H11568

HYDROGRAPHIC TITLE SHEET

General Locality: **Approaches to Chesapeake Bay**

**ATLANTIC HYDROGRAPHIC BRANCH
EVALUATION REPORT to Accompany
Survey H11568 (2006)**

Revised Final Tidal Zoning for OPR-D304-TJ-2006, H11568 Southeast of Cape Henry, Chesapeake Bay, VA

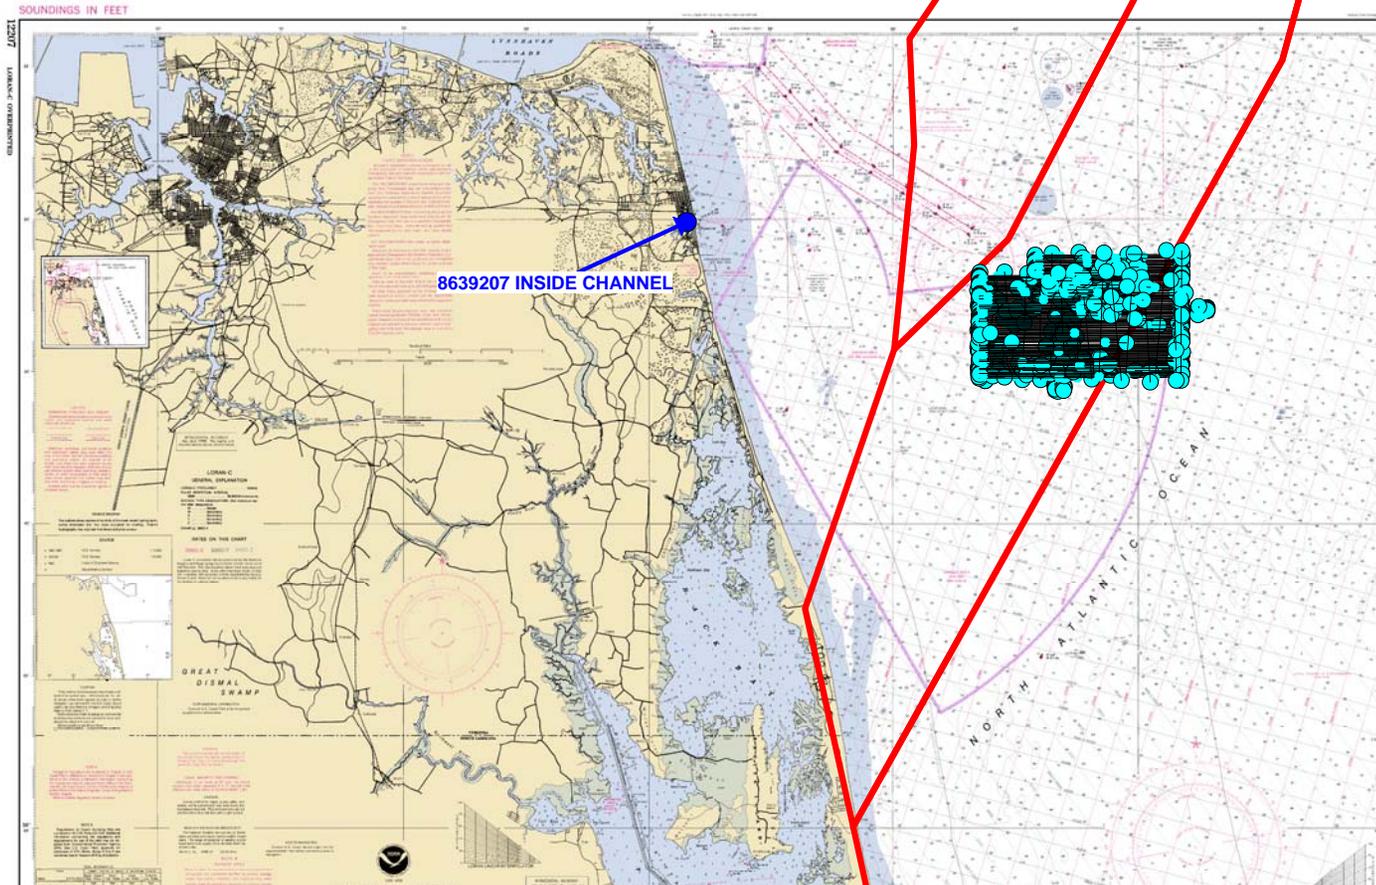
Here is the revised zoning for OPR-D304-TJ-2006, H11568. I ended up just re-doing the whole thing, since what the TJ had applied was from 2005, and the had to manually stretch the zones to cover their survey area. So if you can overwrite whatever tide note you have with this one. Thanks Let me know if you come across any problems, or questions. Hope everything is going well with you.

Incomplete multibeam coverage over AWOIS Item #12994 (Image 1) –

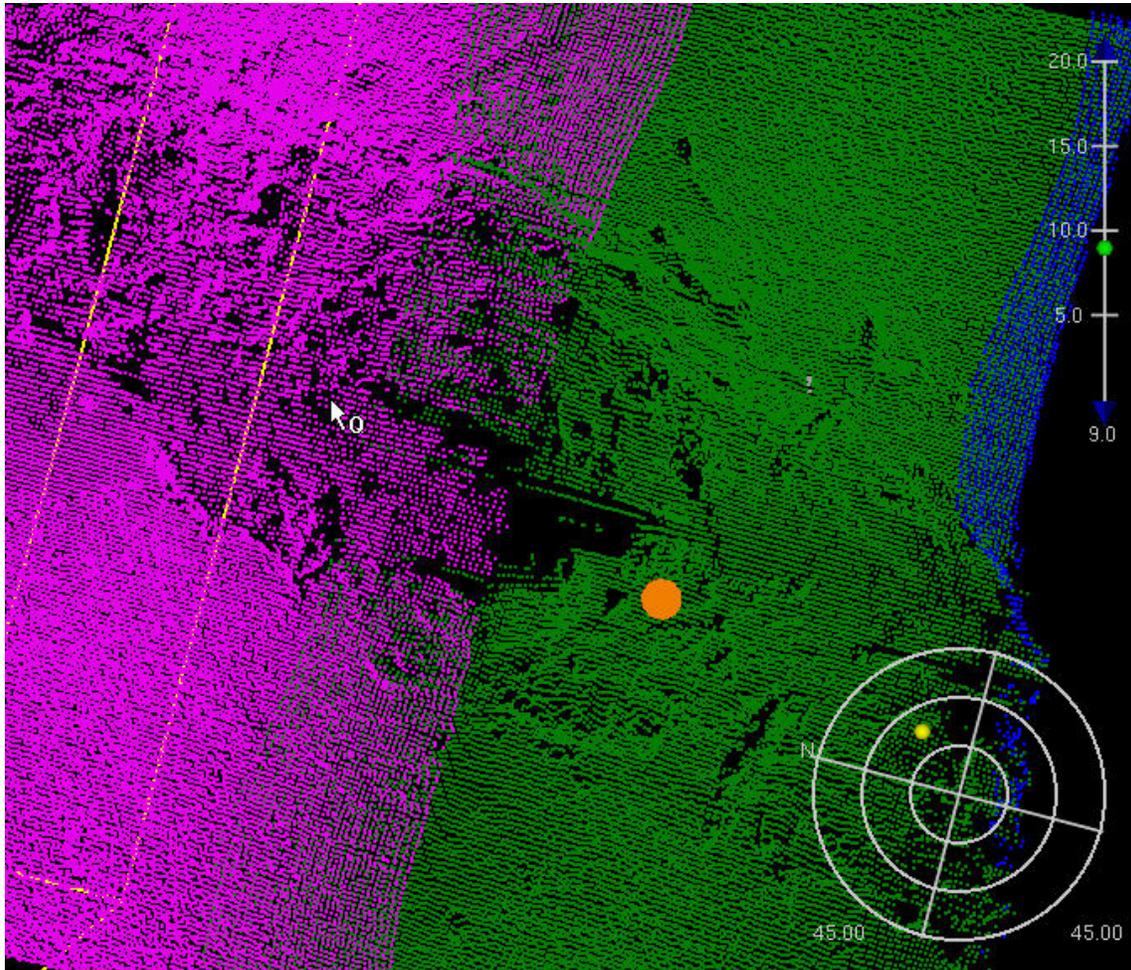
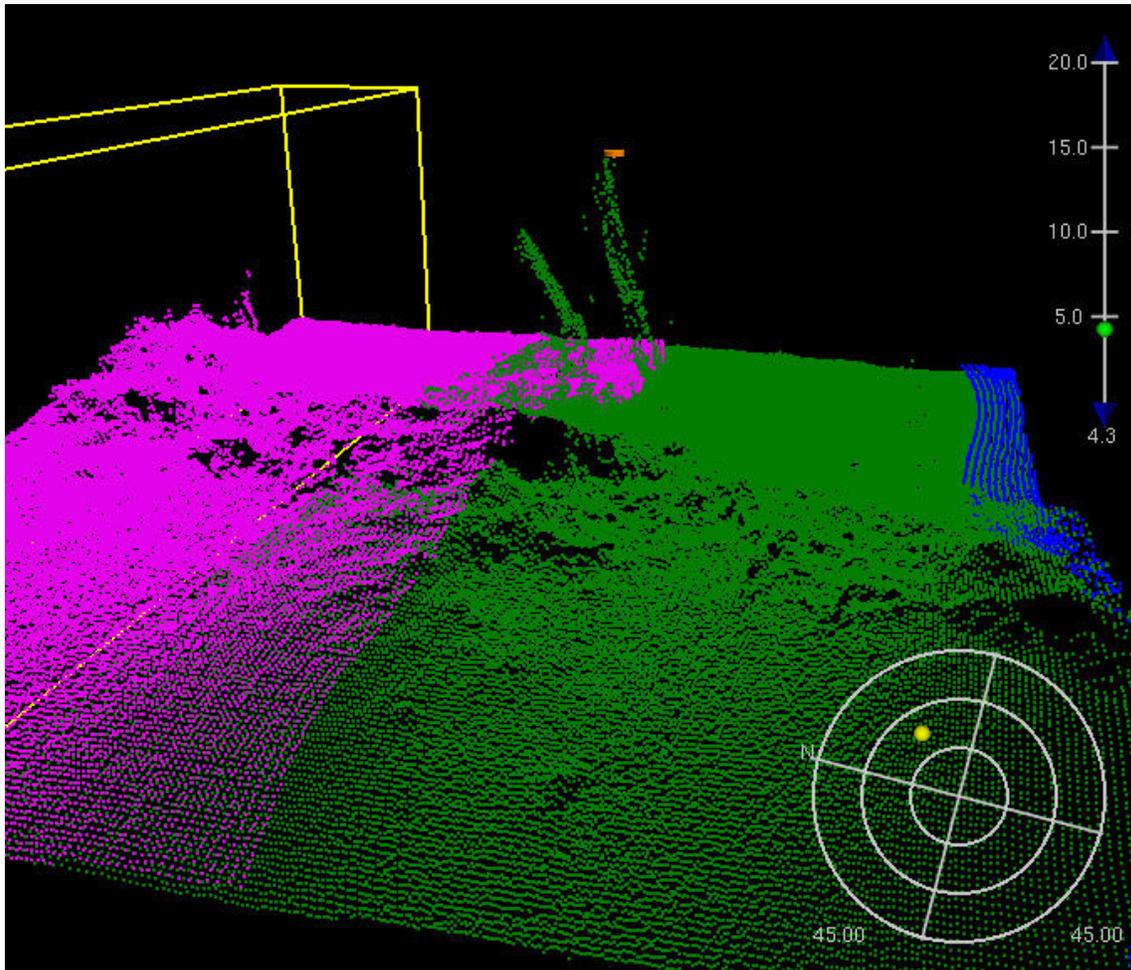
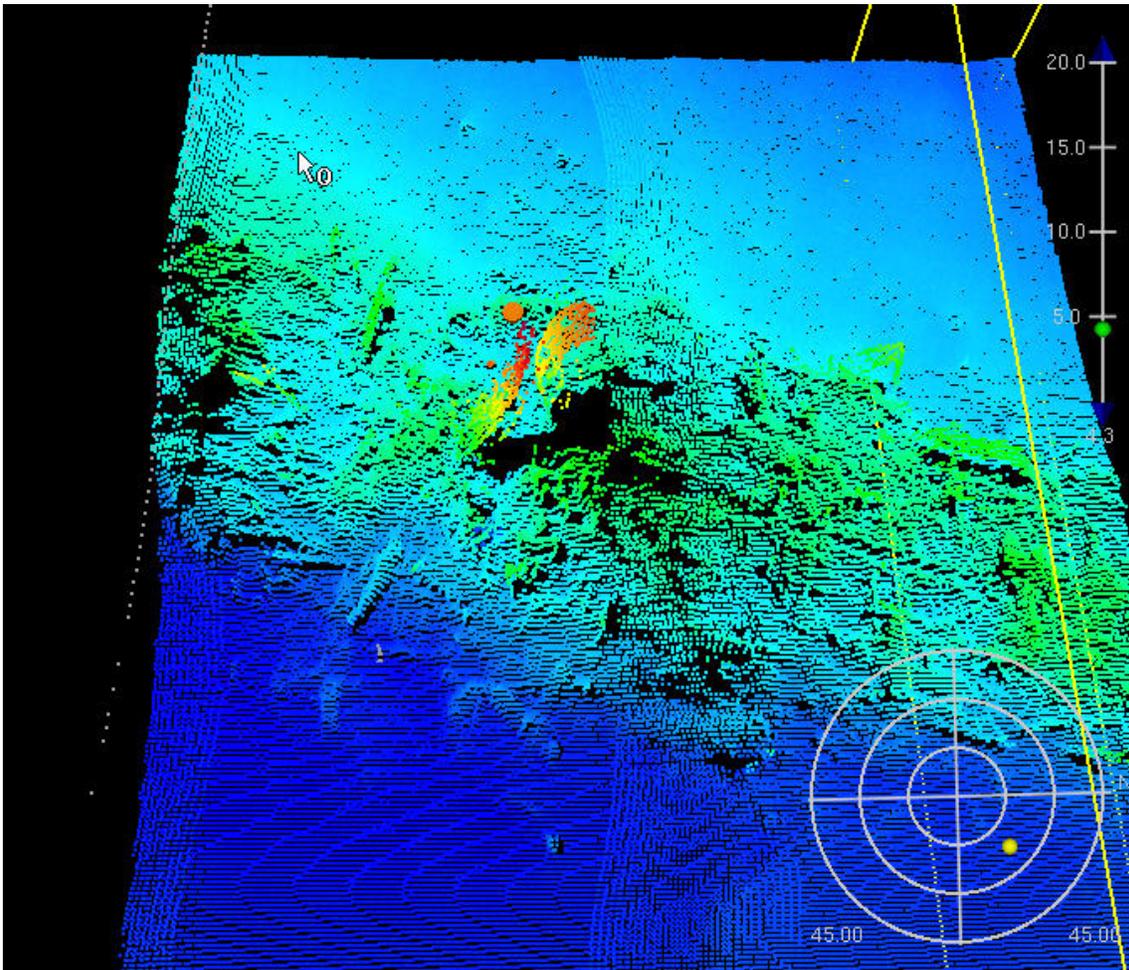
- 1) AWOIS Item #12994 was not completely investigated. The depth is known but the actual least depth is unknown based on shadows created by the angle of ensonification. This AWOIS Item is neither proven nor disproven. Revise the charted dangerous 43 Wreck to a dangerous Wreck with a depth of 38 ft. in Latitude 36° 45' 57.633" N, Longitude 75°

46'16.746" W and recommend the AWOIS Item be listed for further investigation using Object Detection Coverage Parameters. The following images detail the lack of ensonification of the charted dangerous wreck:

Incomplete multibeam coverage over Obstruction (Image 1) –

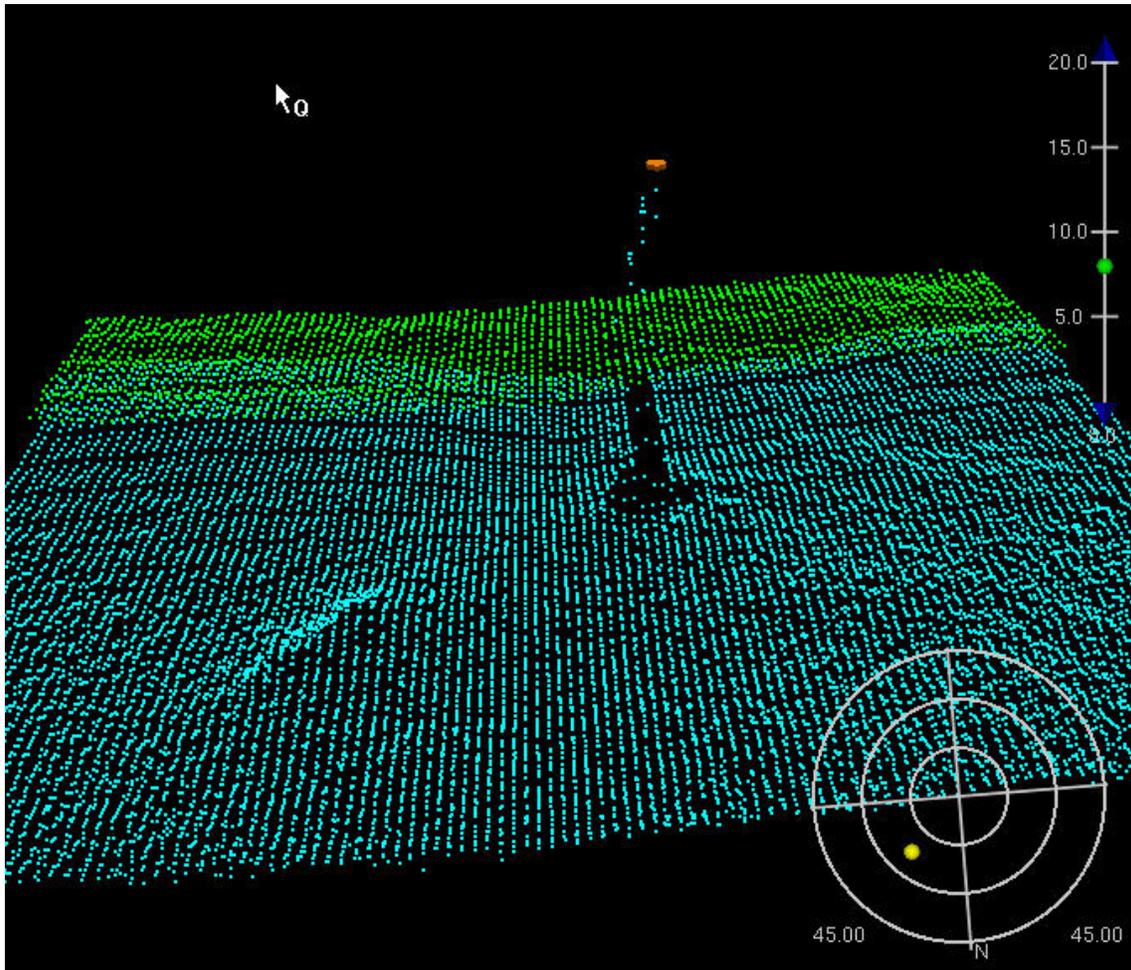
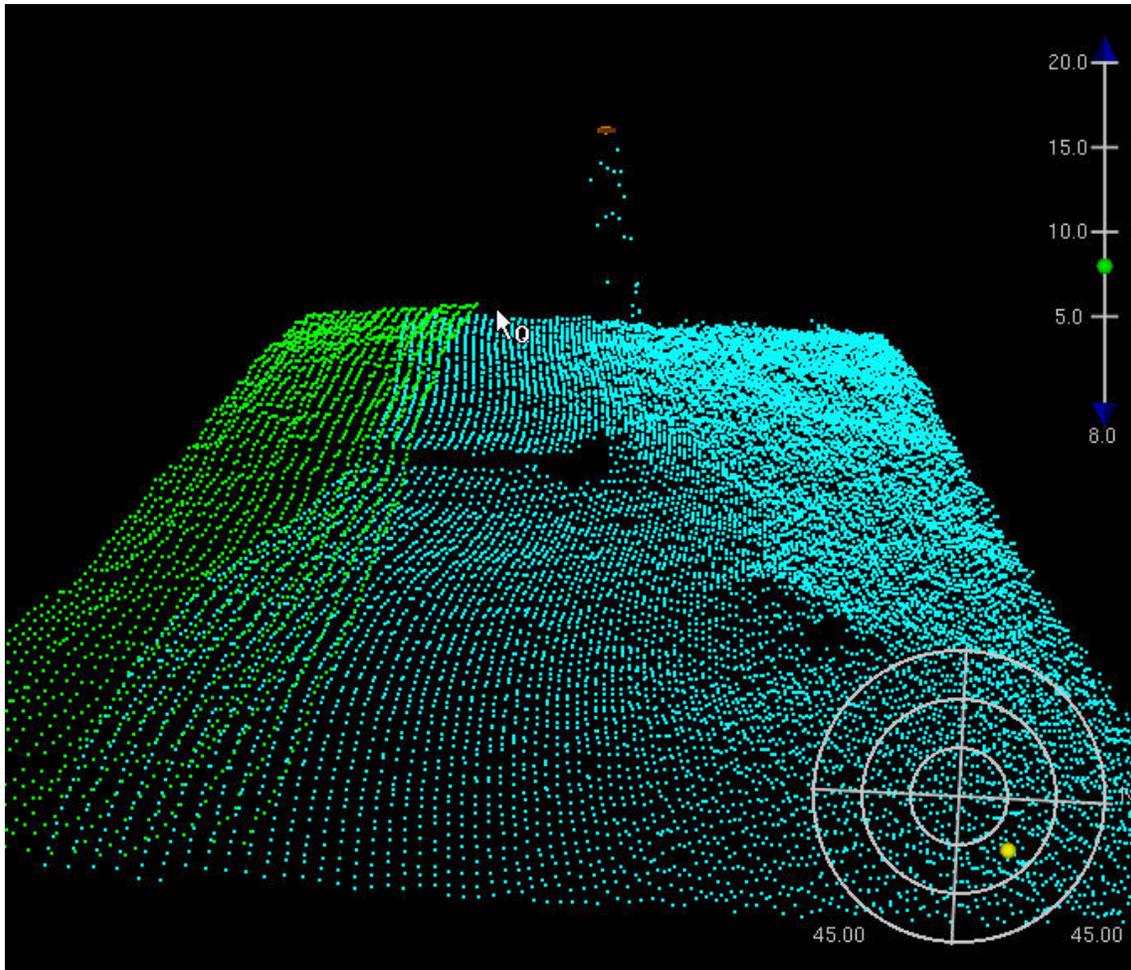
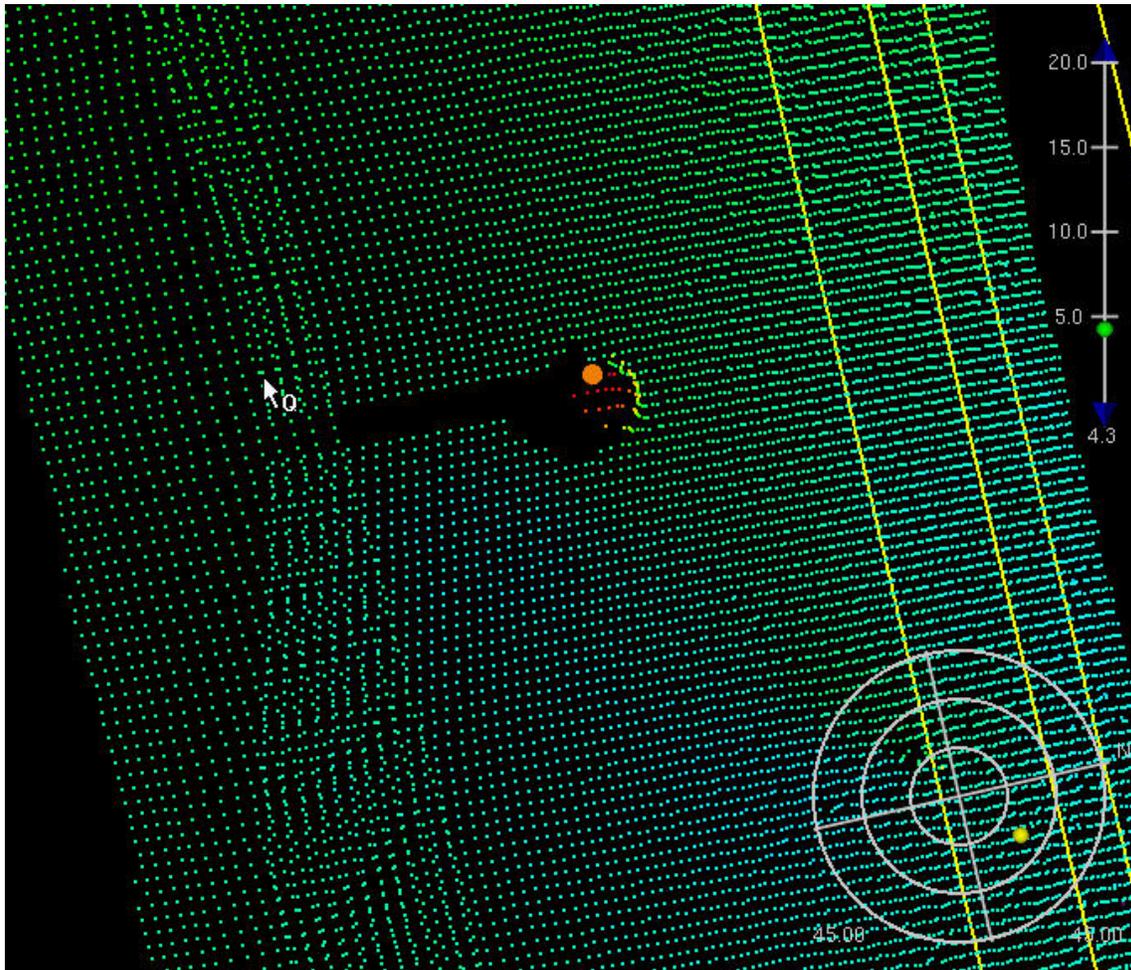
- 2) Northeast of the charted AWOIS Wreck is a new Obstruction, however this feature was not fully investigated either. The depth is known but the actual least depth is unknown based on shadows created by the angle of ensonification. Chart an Obstn with a depth of 53 ft. in Latitude $36^{\circ} 46' 01.596''$ N, Longitude $75^{\circ} 46' 06.926''$ W and recommend the feature be listed for further investigation using Object Detection Coverage Parameters. The following images detail the lack of ensonification of the obstruction:
